HAP 16-057-L
K. Gonyou

TO:	CHAIR AND MEMBERS LONDON ADVISORY COMMITTEE ON HERITAGE MEETING ON WEDNESDAY DECEMBER 14, 2016
FROM:	JOHN M. FLEMING MANAGING DIRECTOR, PLANNING AND CITY PLANNER
SUBJECT:	HERITAGE ALTERATION PERMIT APPLICATION AT 309-311 WOLFE STREET, WEST WOODFIELD HCD BY: NELMS GROUP LTD.

Figure 2: East elevation (provided by the applicant as part of the Heritage Alteration Permit application).

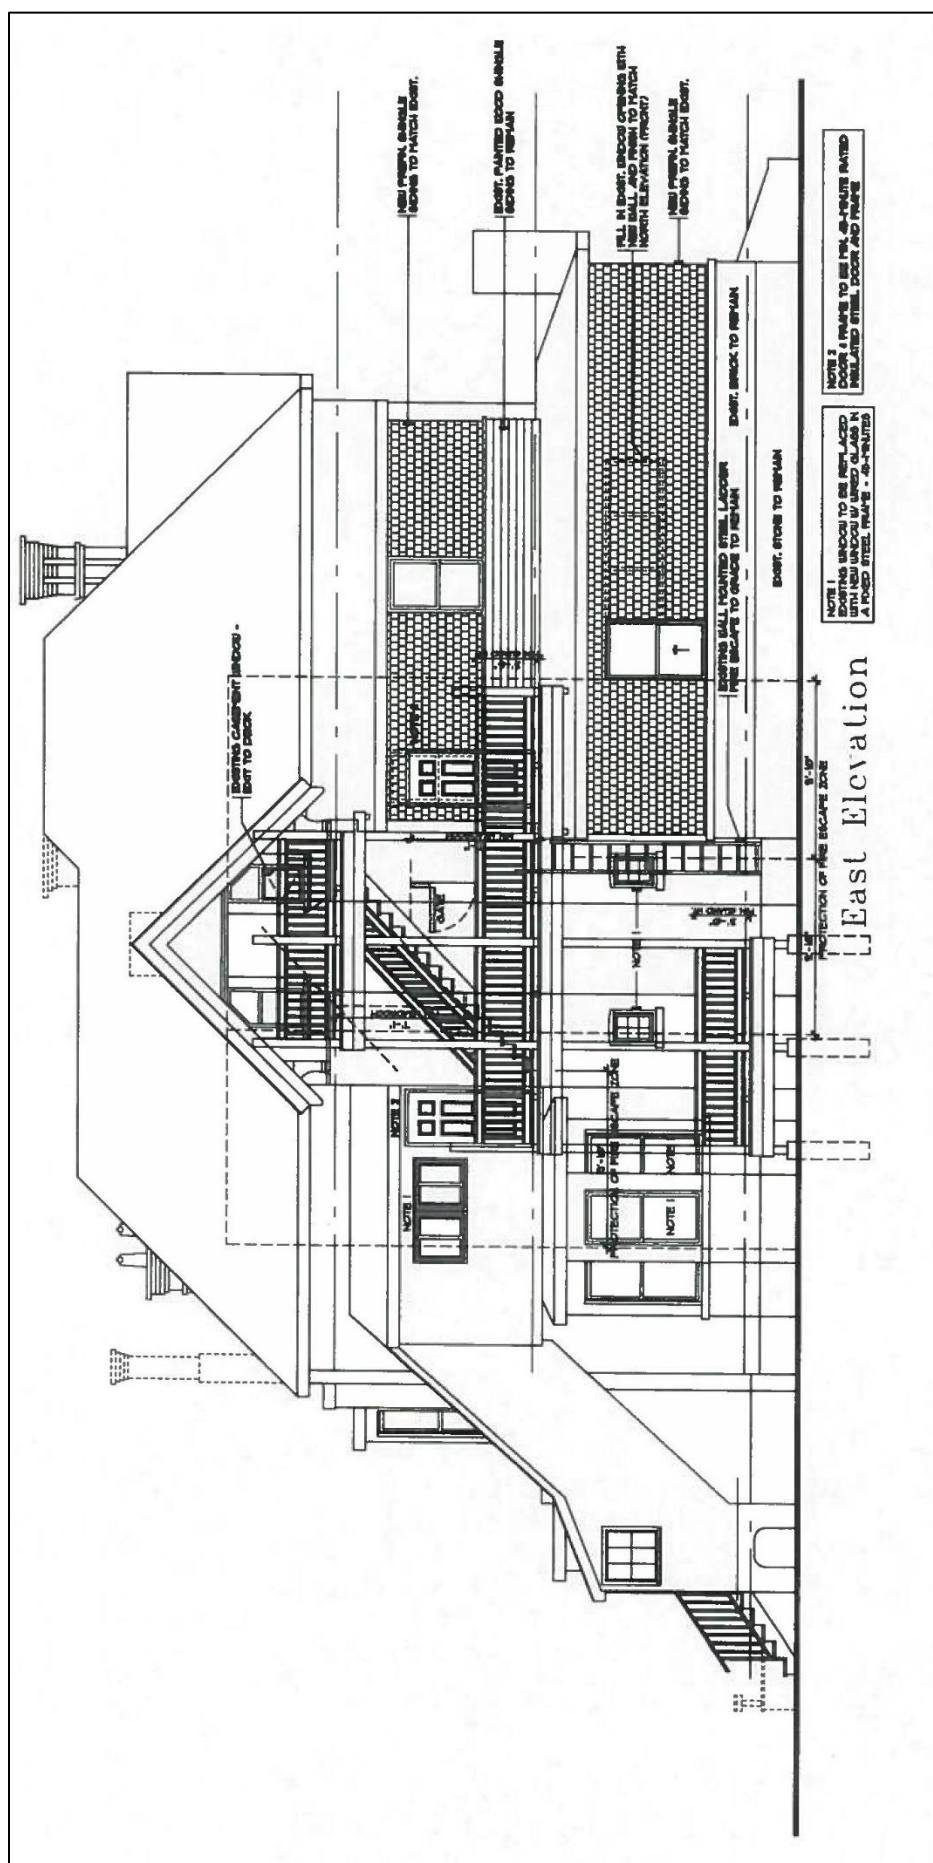
The introduction of a new fire escape must be carefully considered to ensure the conservation of the overall cultural heritage resource and compatibility with its heritage attributes. For the building at 309-311 Wolfe Street, a fire escape has been proposed on the east façade of the building, recessed from the primary (north) façade (see Appendix C). This has been done to minimize any visual impact of the proposed fire escape. The proposed fire escape will provide access to the second and third floors of the building with an exterior landing. The proposed fire escape will be constructed of wood, including wood balustrade in a traditional style (see Appendix C). The proposed fire escape should be painted or stained to blend into the architectural details of the building.

- a. Restoration work be completed within one year to Chimney 3 (as identified in the Appendix D) to its full historic height and detailing using compatible buff brick material and lime-based mortar;
- b. The applicant be encouraged to consider a triplet of sash windows with wooden mullion details for the north gable window replacement;
- c. The addition of the fire escapes be constructed as reversible interventions;
- d. All exposed wood be painted or stained; and,
- e. The Heritage Alteration Permit be displayed in a location visible from the street until the work is completed.

Figure 4: West elevation (provided by the applicant as part of the Heritage Alteration Permit application).

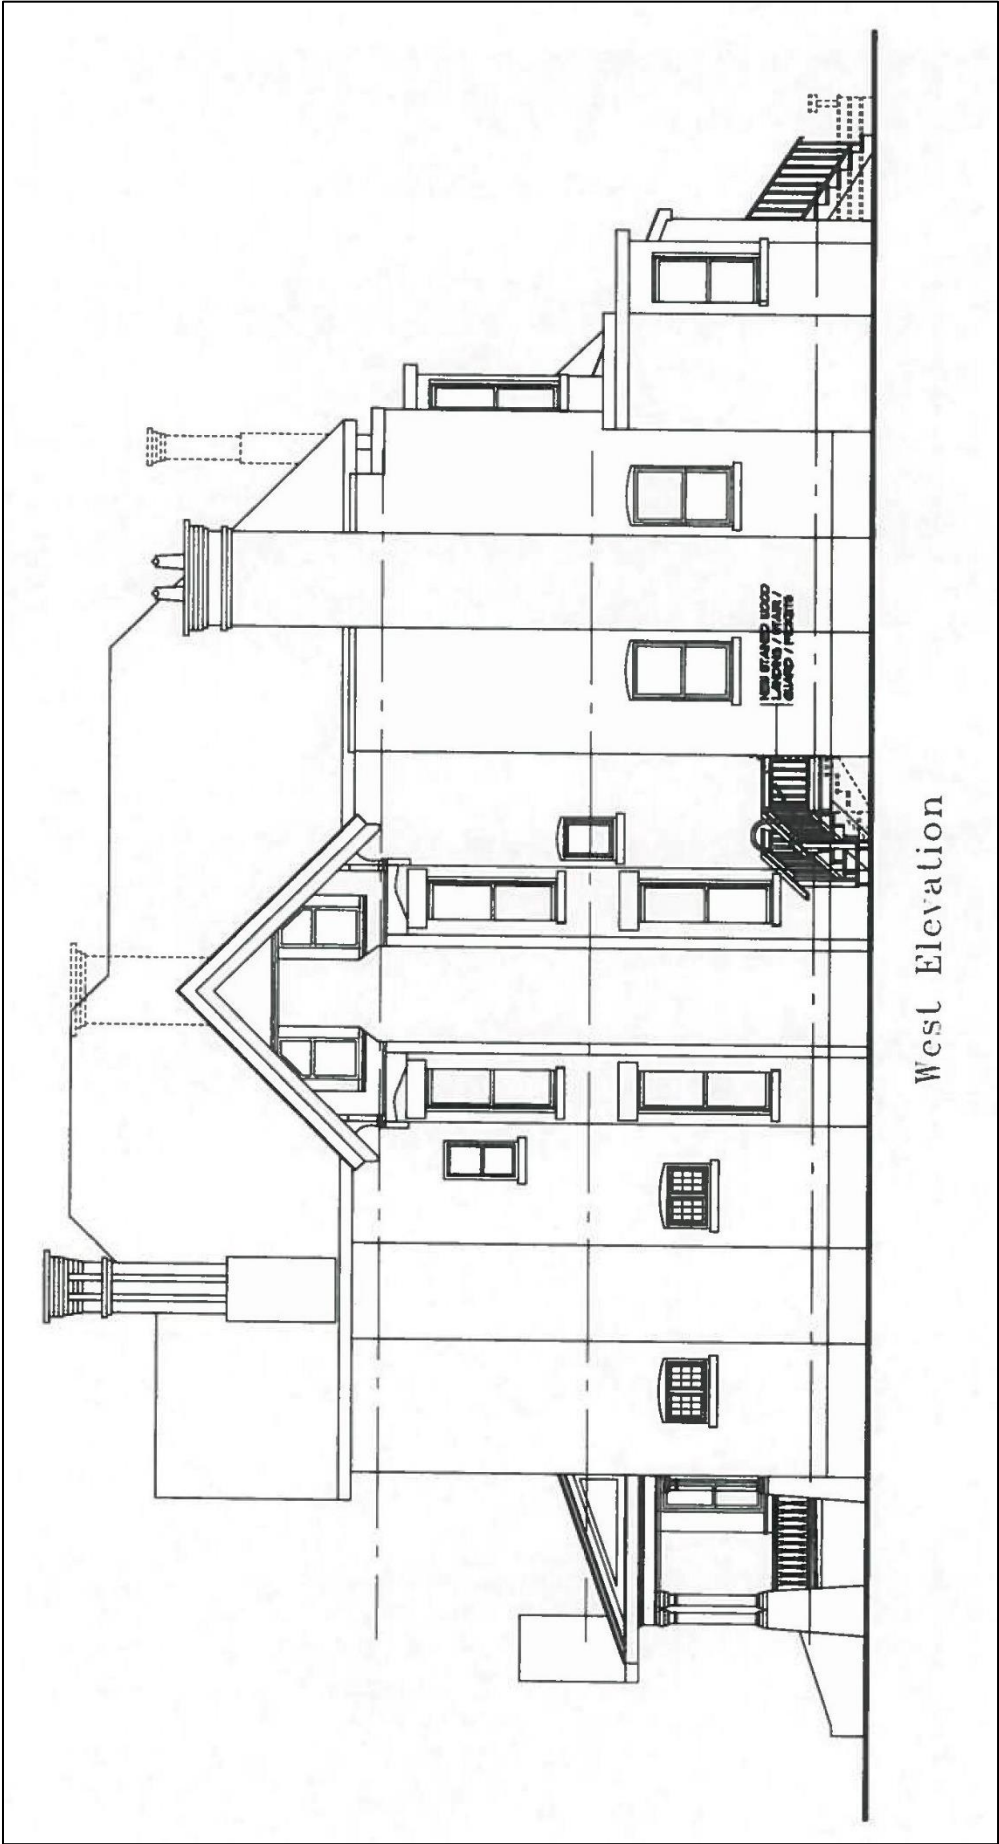
The existing west access to the building is deficient in terms of its dimensions, form, and aesthetic compatibility with the remainder of the building. The proposed replacement west porch seeks to establish a landing at the west entry to the building, constructed of wood and accessed by wooden steps and surrounded by a wooden balustrade in the style of proposed fire escape (see Appendix C). Like the proposed fire escape, the proposed west porch should be painted or stained to blend into the architectural details of the building.

Figure 1: Chimney Schedule (provided by the applicant as part of the Heritage Alteration Permit application).

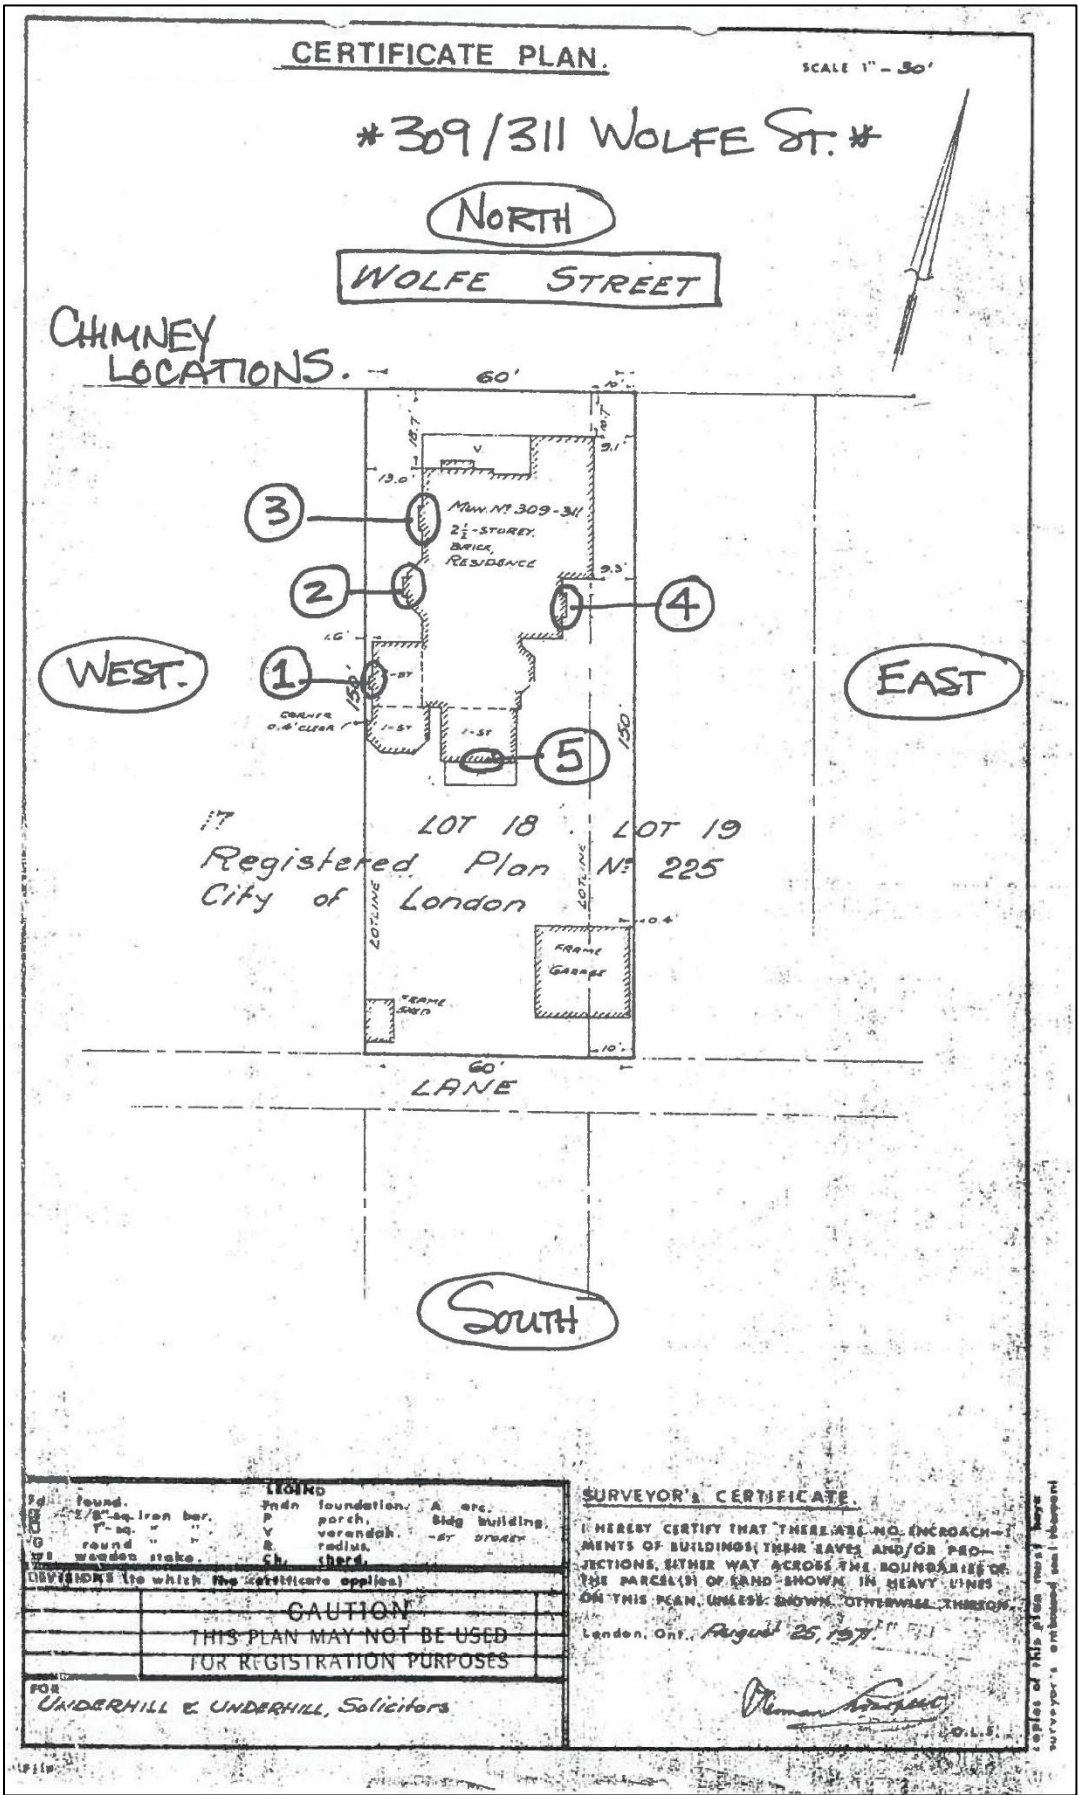
From further discussion with the Heritage Planner, the applicant has proposed to remove the three least decorative chimneys (Chimney 2, Chimney 4, and Chimney 5) in favour of retaining Chimney 1 and restoring Chimney 3 to its historic height and detailing. While this represents a compromise, this allows the applicant to target their available resources to the greatest impact by restoring the most decorative and significant chimneys.

The other chimneys should be removed and capped in aluminium (or comparable) at the roofline.

Figure 2: Note for Chimney 3 (left): “Rebuild chimney to tis former height an appearance as per photo on this sheet.” Note for Chimney 2 (right): “Existing chimney to be removed.”

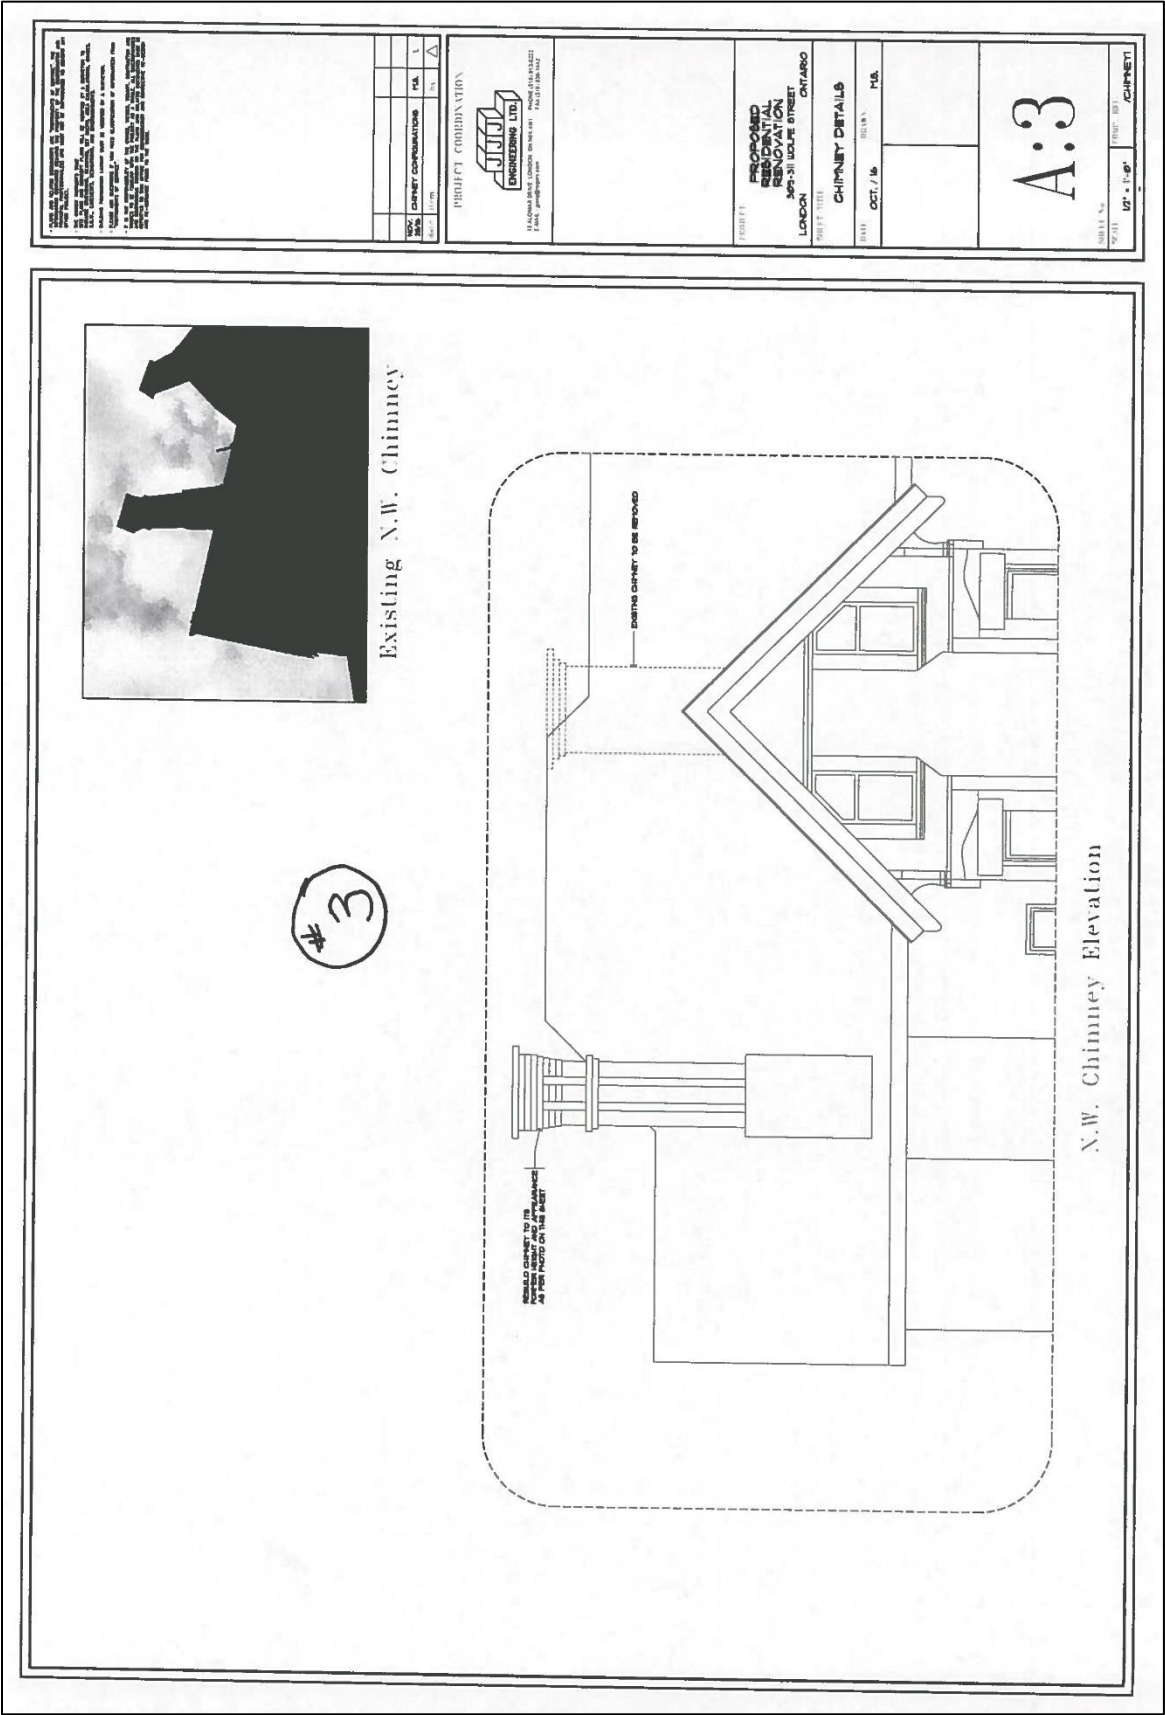
All of the chimneys at 309-311 Wolfe Street are constructed of the same buff brick and lime-based mortar as the building itself. To appropriately restore the historic height and detailing of Chimney 3, appropriate materials must be used. Salvage brick may be required. A drawing has been prepared to guide the restoration of Chimney 3 (see Appendix D). Given the seasonal limitations of the application of lime-based mortar, wintertime restoration of Chimney 3 is not recommended. Restoration of Chimney 3 should be completed within one year.
